REGIONAL REVIEW FINDING

Name of Proposal: Fairburn Storage

Review Type: Development of Regional Impact

Preliminary Report:	June 16, 2008	DEVELOPMENT OF REGIONAL IMPACT REVIEW REPORT	Project:	Fairburn Storage #1875
Final Report Due:	July 16, 2008		Comments Due By:	June 30, 2008

OVERALL LAYOUT & STAKING PLAN

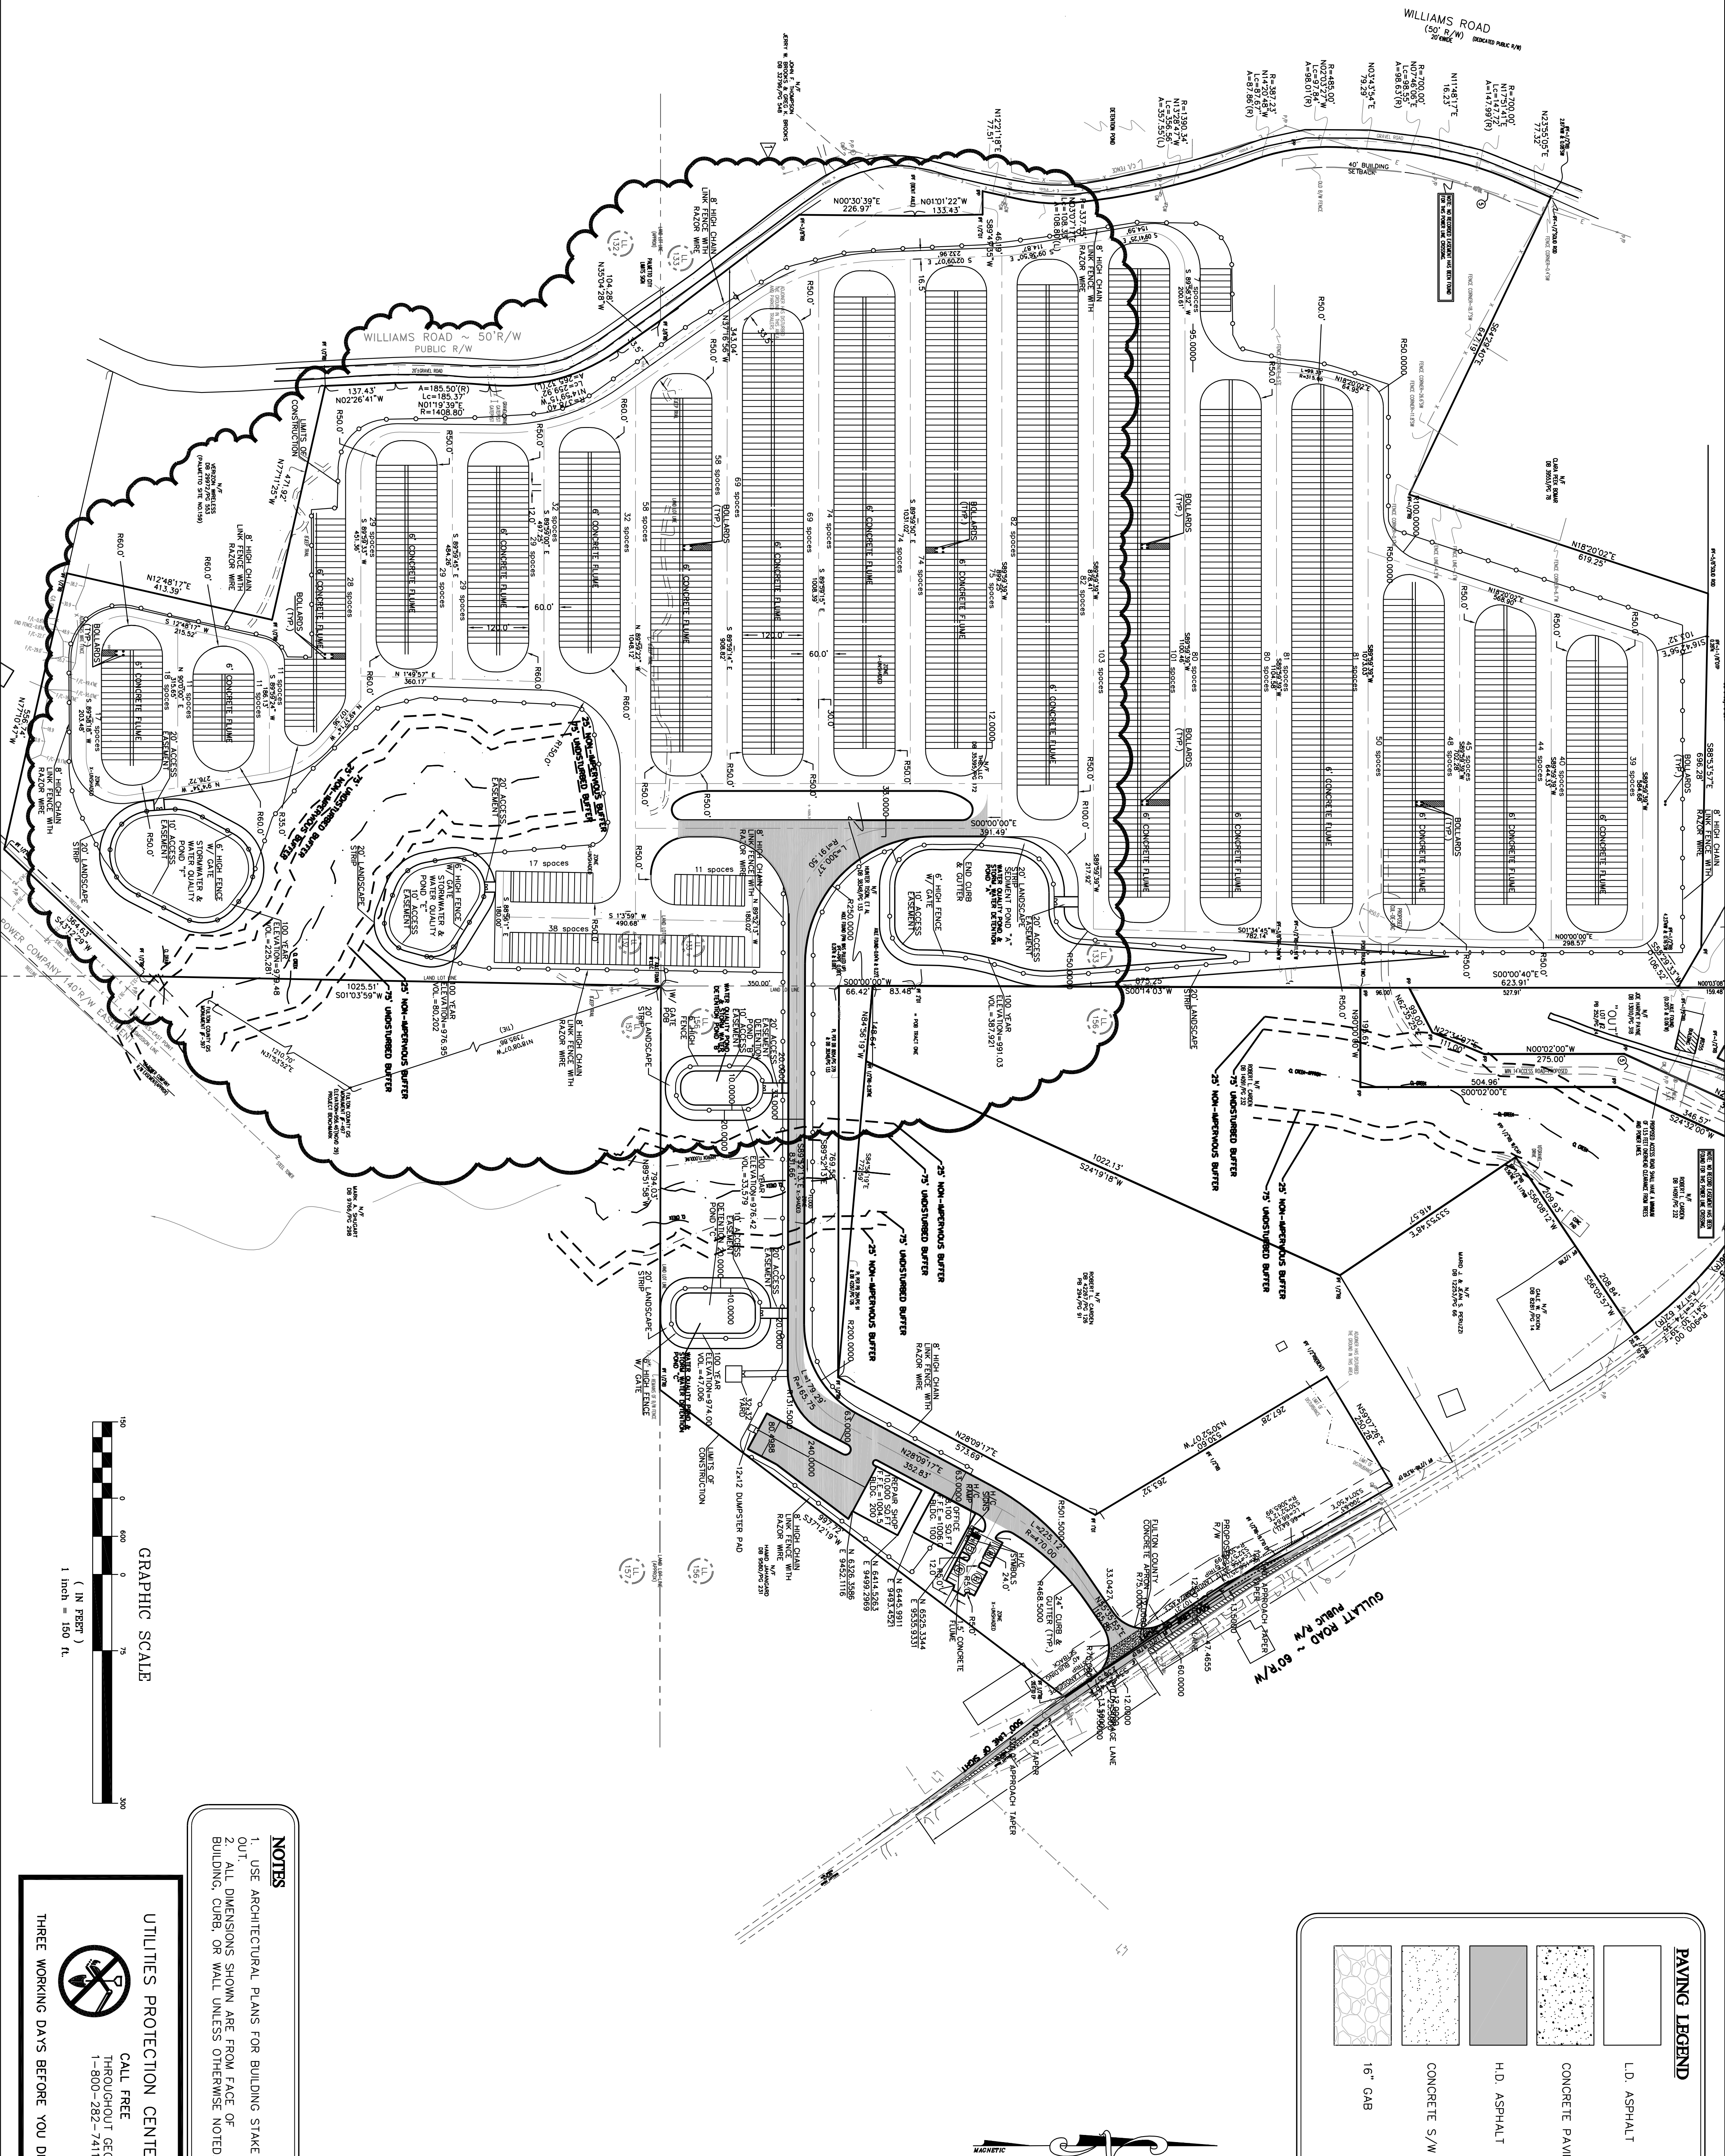
Although no plans were submitted at scale, the site appears to be about 80 percent impervious. Water quality control ponds are also shown on the site plan. The project needs to conform to all County water supply watershed requirements, including impervious surface and water quality best management practices requirements.
